TECHNICAL MEMO

Geotronics AB, Technical Support Dept., Danderyd, SWEDEN, September 1997

TI/9702A

- Level:** 3.
- Instrument type:** Geodimeter system 600.
- Subject:** Vertical servo not working.
- Description:** The vertical servo function on the SRV and SRV2 boards can break due to ESD through the vertical servo knob. Replace IC46 and IC49 on the SRV/SRV2 boards to LM6482 RAIL-RAIL OP X2.
- IC46, IC49 LM6482 RAIL-RAIL OP X2 Part no: 571 804 246
- Mark the SRV board with rev. D02/08 and SRV2 board with rev. D00/04.
- Perform this modification if the vertical servo is not working.

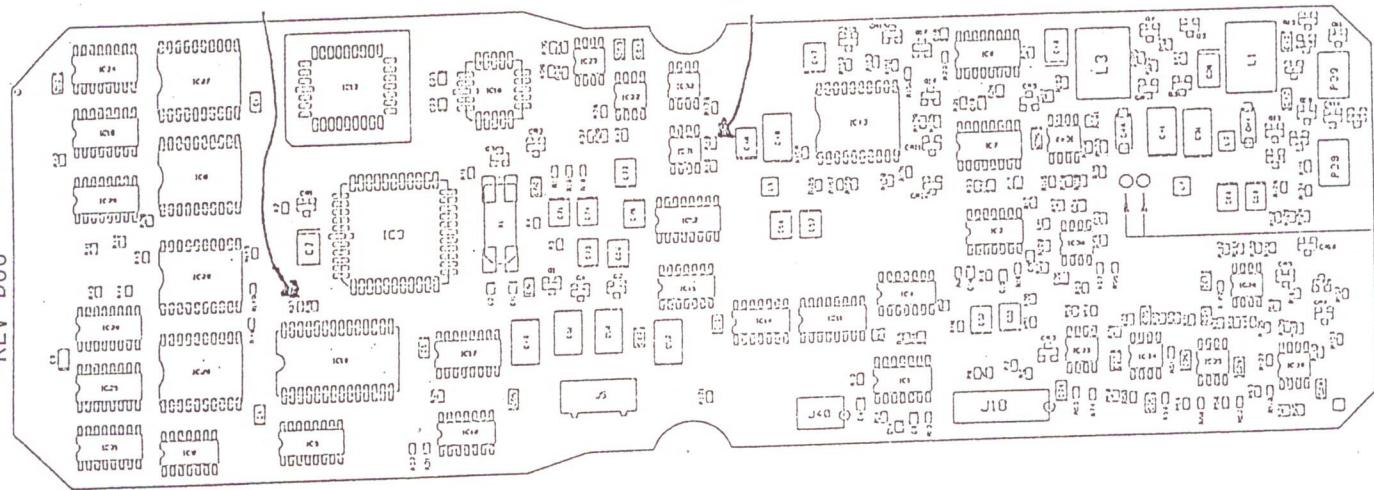
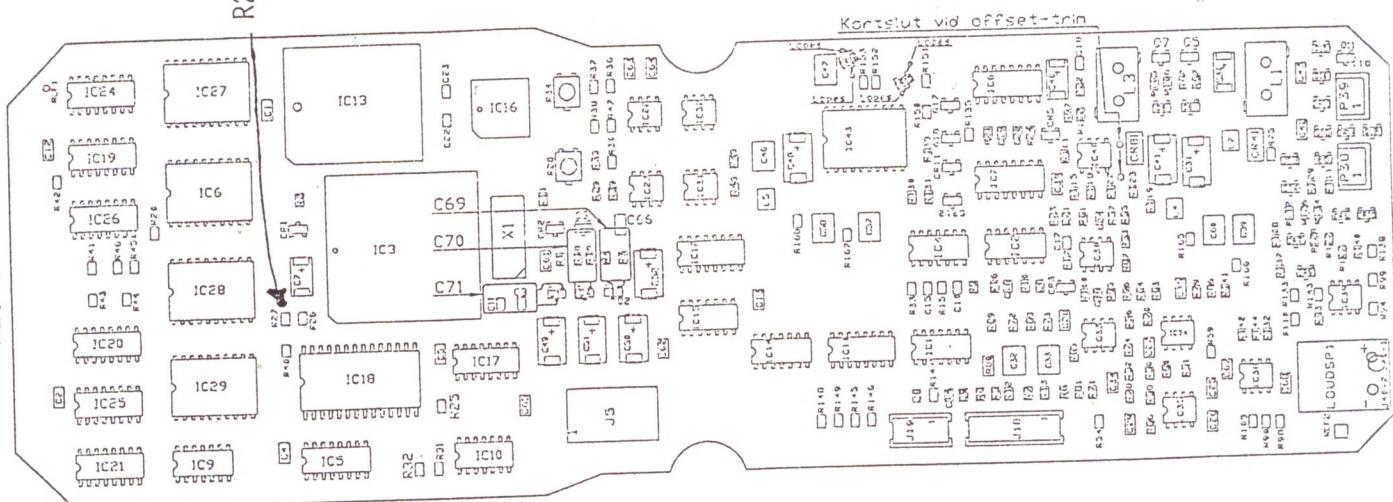
Description: Ensure correct allocation of the memory ( IC18 ) ,

Remedy: Remove resistor R 27 => see diagram, R 26 must be mounted only.

Mark the board rev. D00/05 (incl. TM/ 9408A)

(1) ESCAP motor mounted

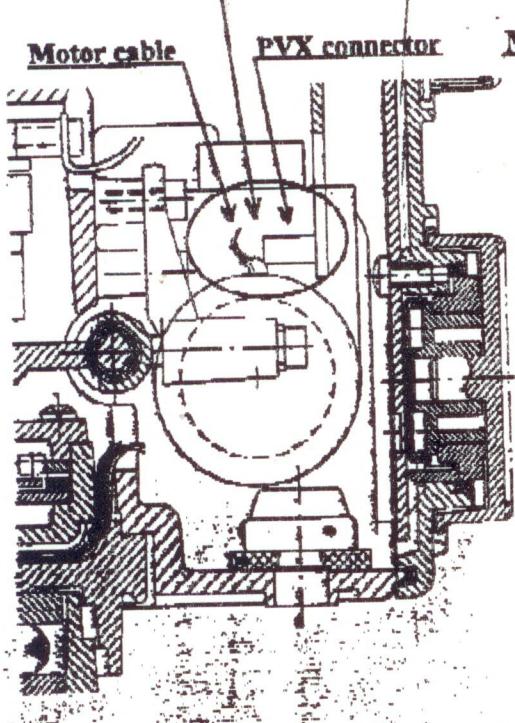
Description: If a motor of type ESCAP\* (1. To tight fit) is mounted in horizontal position, it has to be changed to a type MiniMotor (2. Correct fit).

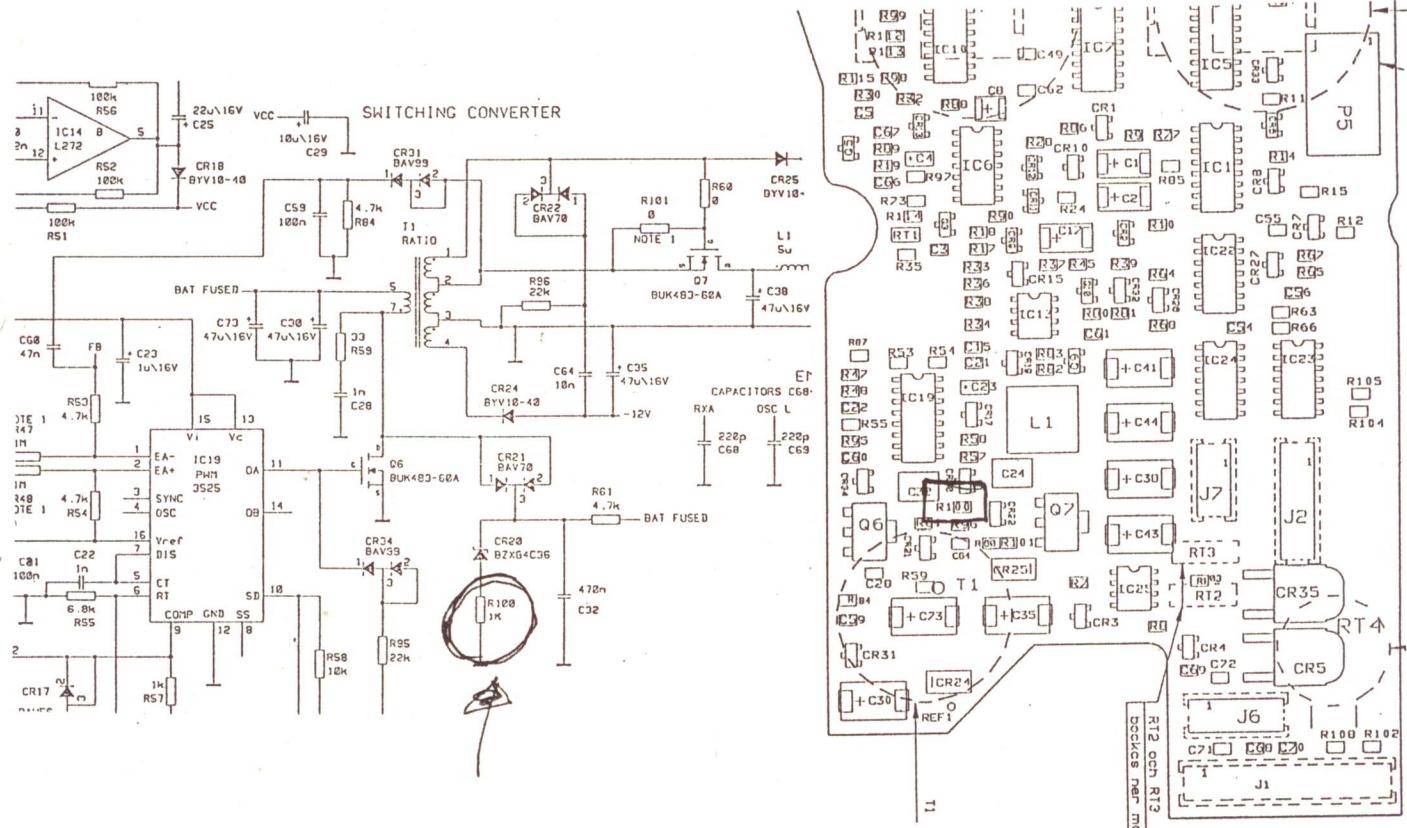
**Description:** Q5 and Q6 are at risk to become damaged by transients from T1 at switch on.

Replace resistor R100, 1Kohm to 22,0 ohm ==> part no: 571 806 109

Components encl. Board is then marked D00/03

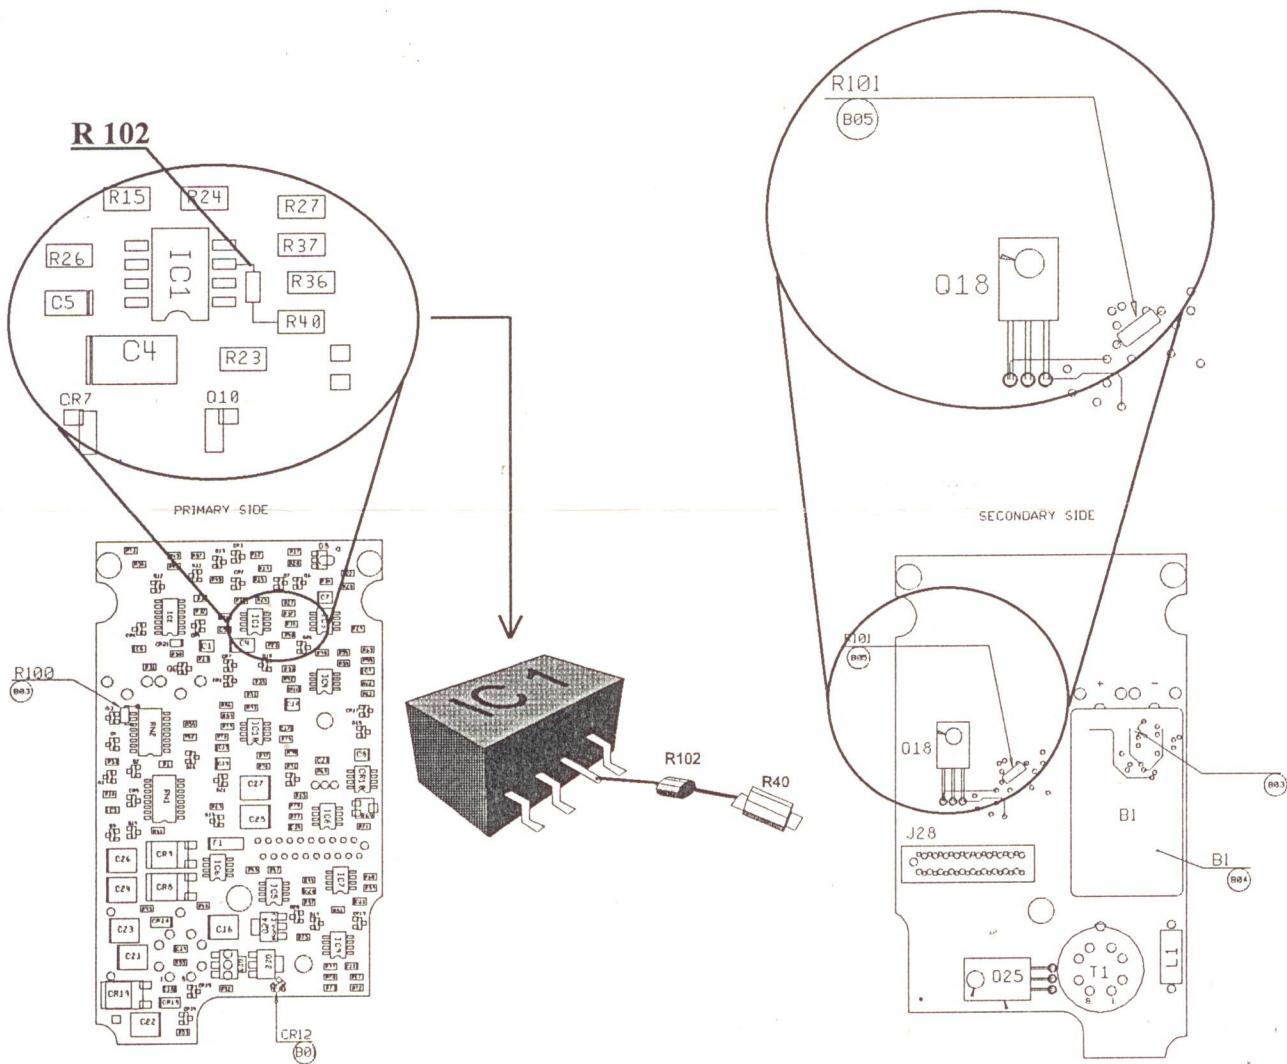
Symptom: Poor range of radio, info 103

Description: Remove the revision B05 modification TM9303A(if modified).  
 Lift pin 3 on IC 1 from soldering pad.  
 Connect R102 (571 902 400) 10k resistor between IC 1 pin 3 and R40 see picture below. Mark the board **B06**

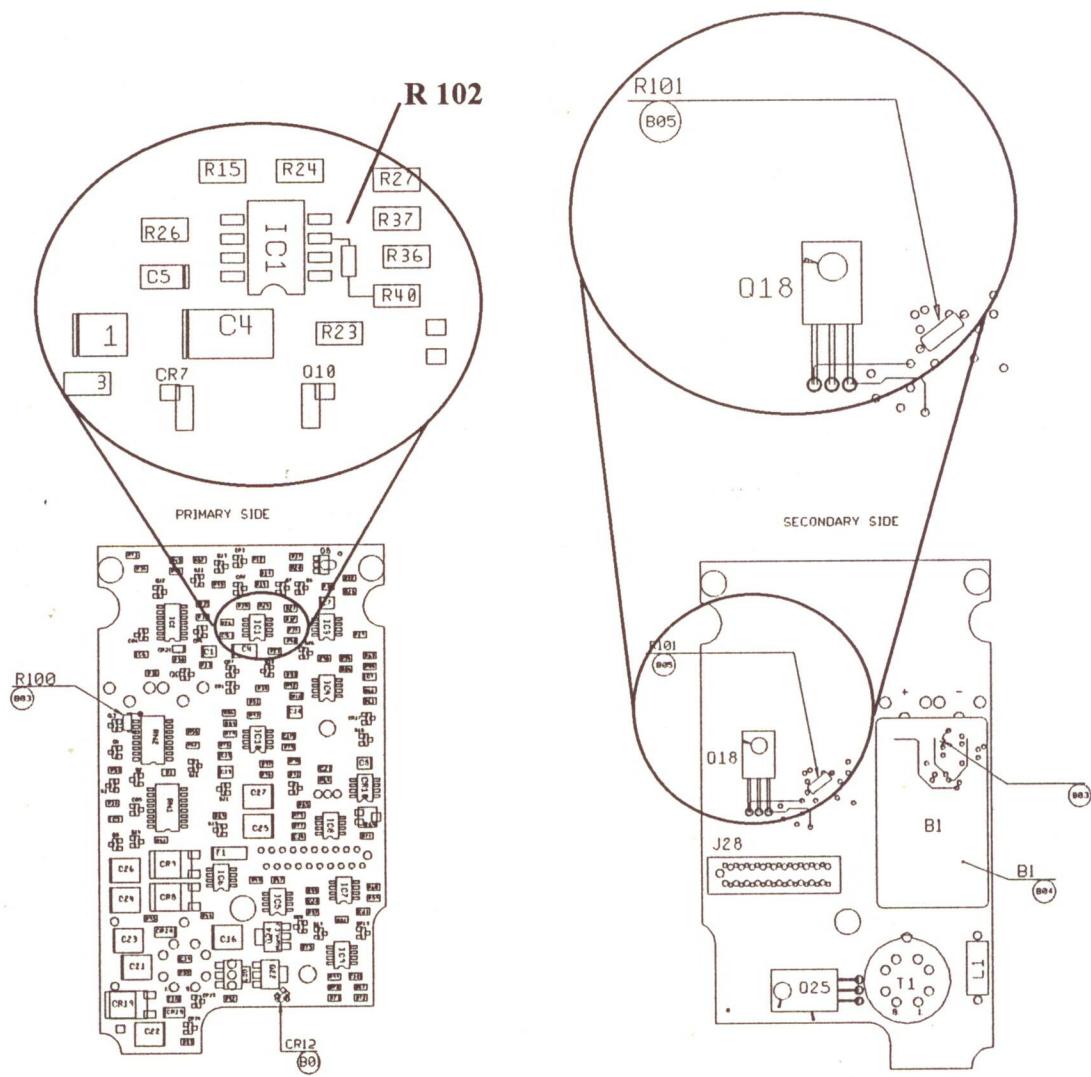
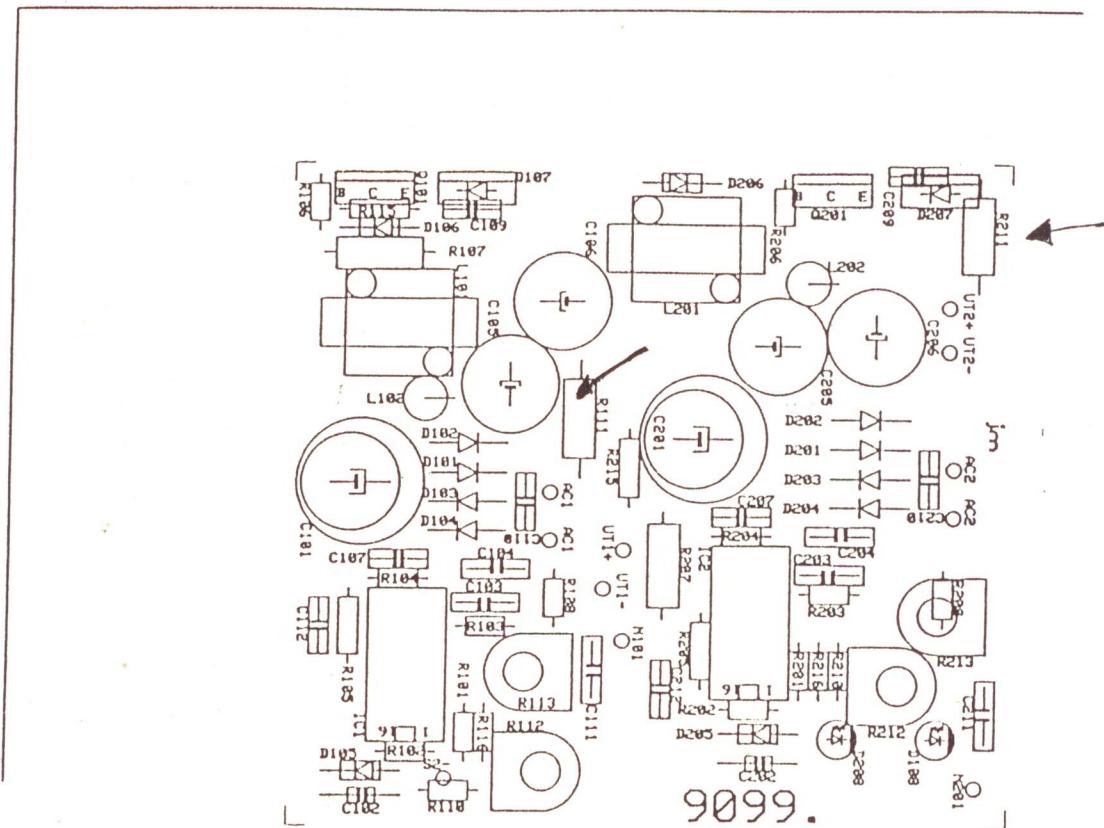
**Symptom:** Poor range of radio, info 103

**Description:** Remove the revision B05 modification TM9303A(if modified) connect a 10k resistor R102 (571 902 400) between IC1 pin 3 and R40 according to picture below. Mark the board **B06**

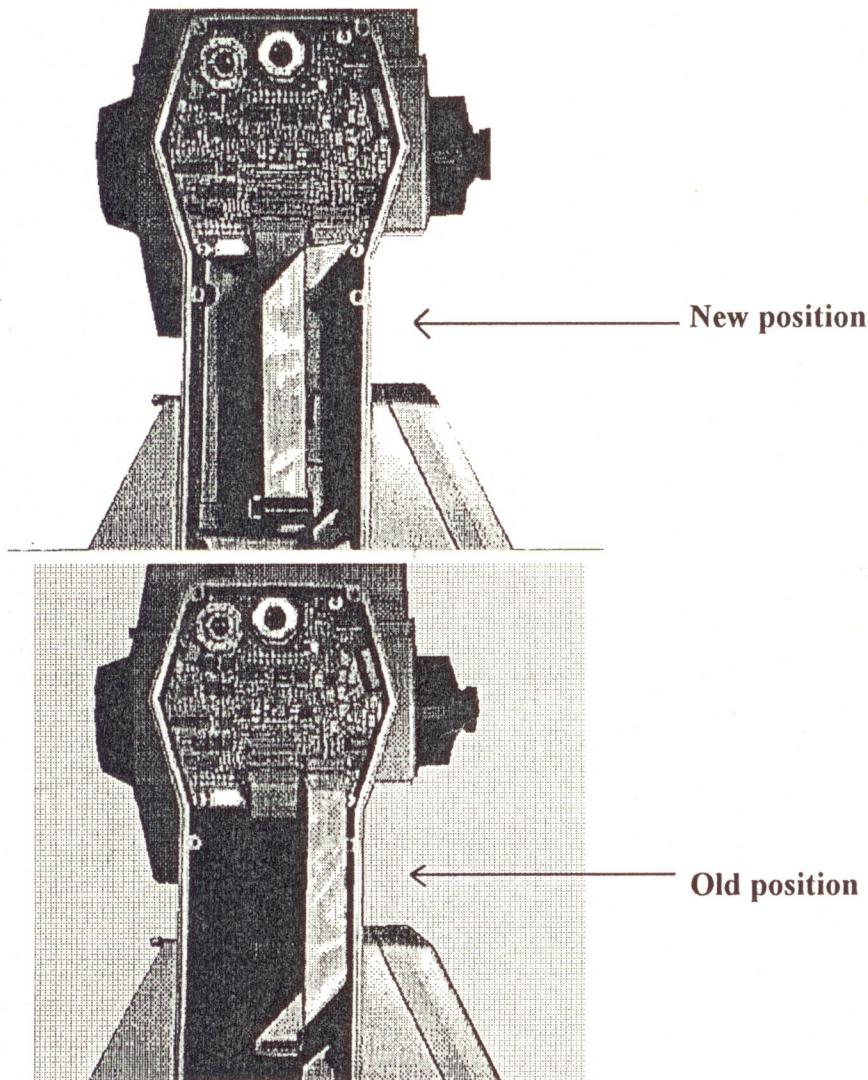
Subject: Eliminate interference between POA - Compensator cable and POA - COP1 cable. Could cause a change of the compensator offset by 20 - 40<sup>cc</sup>.

Description: Change position of cable from POA - Compensator according to pictures bellow.

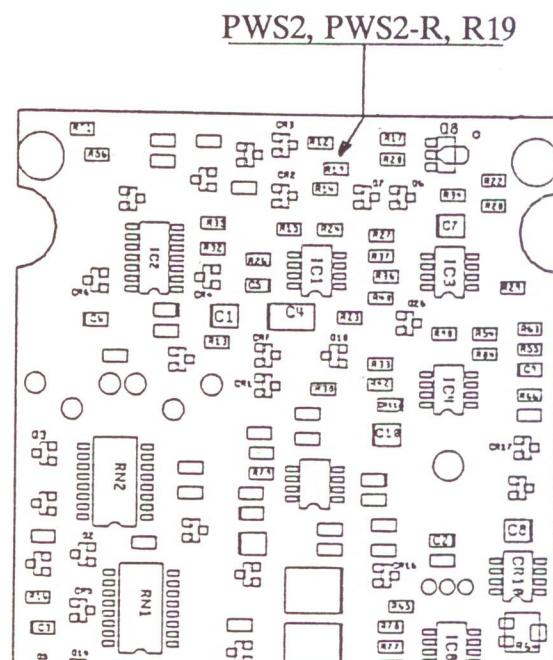
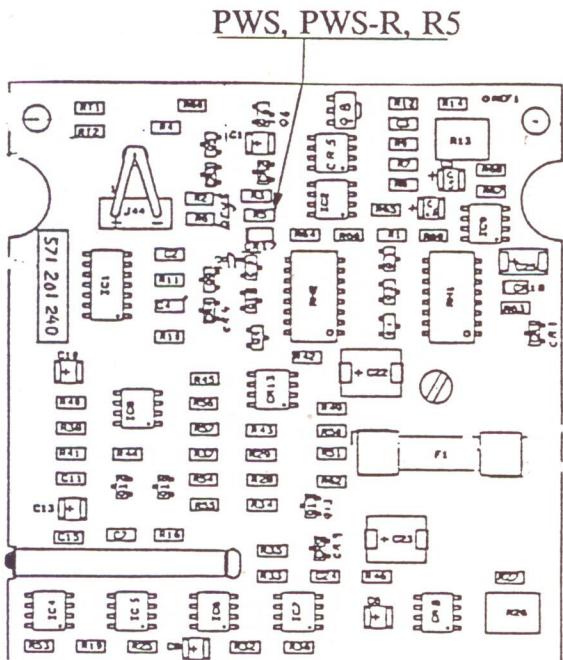
GEOTRONICS AB  
Geodimeter Division  
Technical Support Dept.  
DANDERYD, Sweden  
571/92006Instrument type: GEODIMETER SYSTEM 400, 500, 4000.Subject: No power offDescription: Some GDM SYS 400, 500, 4000 instruments have intermittently been unable to switch off. The cause of that is a timing mismatch on the power board, this concerns PWS, PWS-R, PWS2 and PWS2-R.

Modify PWS and PWS-R by changing the resistor R5 from 10k ohm to 100k ohm part no:571 800 501.

Modify PWS2 and PWS2-R by changing resistor R19 from 10k ohm to 100k ohm part no:571 800 501.

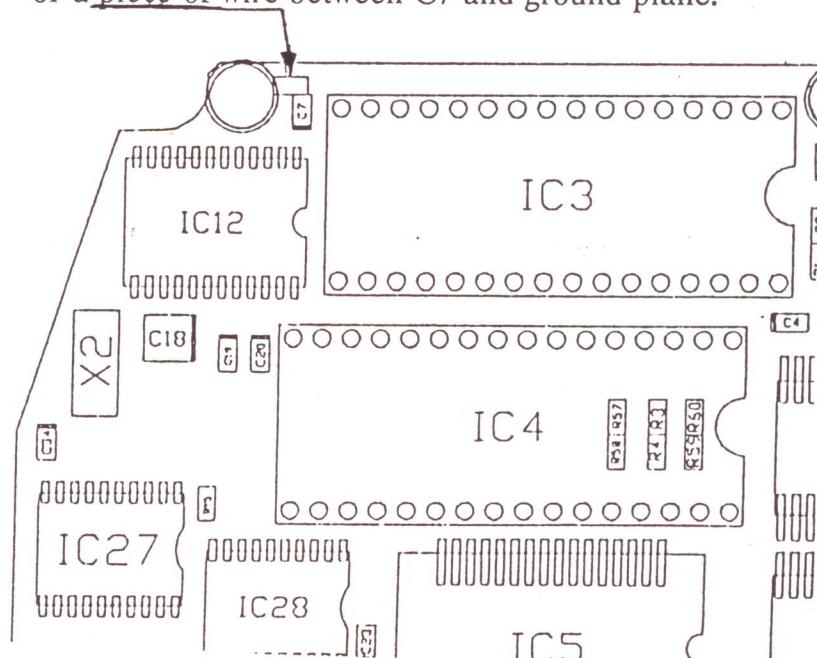
Symptom: Program irregularities

Ground connection of PROM 21 (IC3) is open but must be closed by connection of a jumper resistor (571 800 000) or a piece of wire between C7 and ground plane.

Remove the screw permanently and solder to the ground plane (around the hole).

Revision changed to C01.

### 1. Changing X1 on the DIP board.

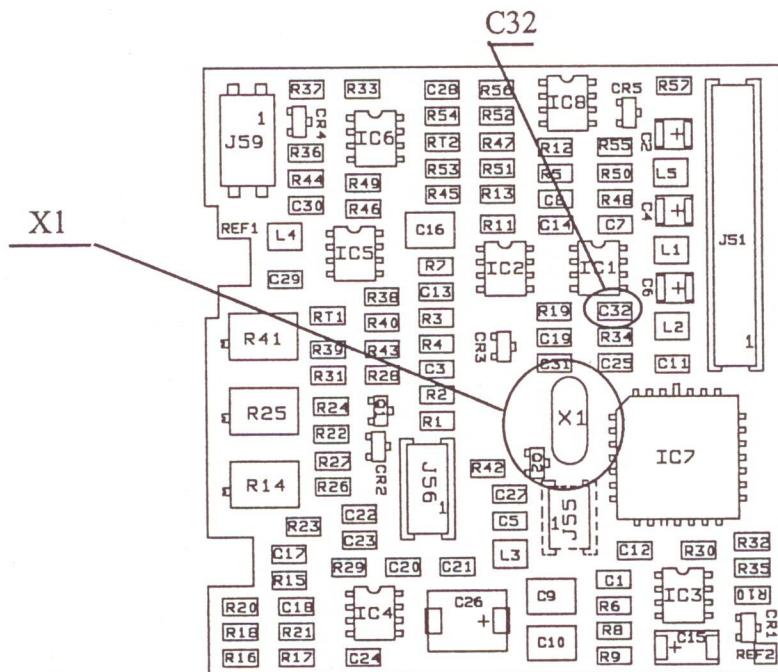
Loosen the three screws and remove the top cover of the GDM. Loosen the DIT(-H) and DIC boards, check the X1 type and if it is a KOYO type, remove the DIP board and carefully remove X1 and remount a TELEQUARTZ type X1.

The KOYO type is identified by the KOYO name that's printed in black text on the crystal. When changing crystal also change C32 to 100pf.

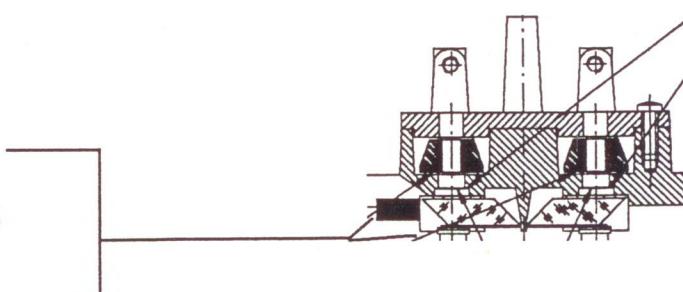
Loosen and remove the three screws  
182,183 in the picture.

Carefully remove the cover, the  
three steel balls 175 and the ferul  
holder 170,172.

After cleaning, assemble the greywedge unit add a teflon washer, part no: 571 200 556 under the ferul holder. Remount the boards and perform optical and electrical adjustments.

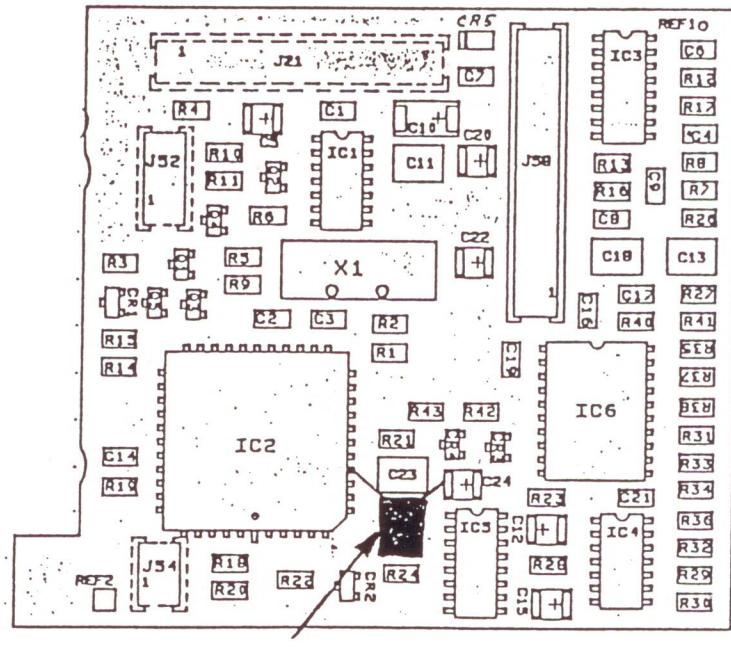
Description: Capacitor C26 (100nF) 571 902 773  
connected to IC2/10 to ground at C24

REVISION CHANGED TO B03
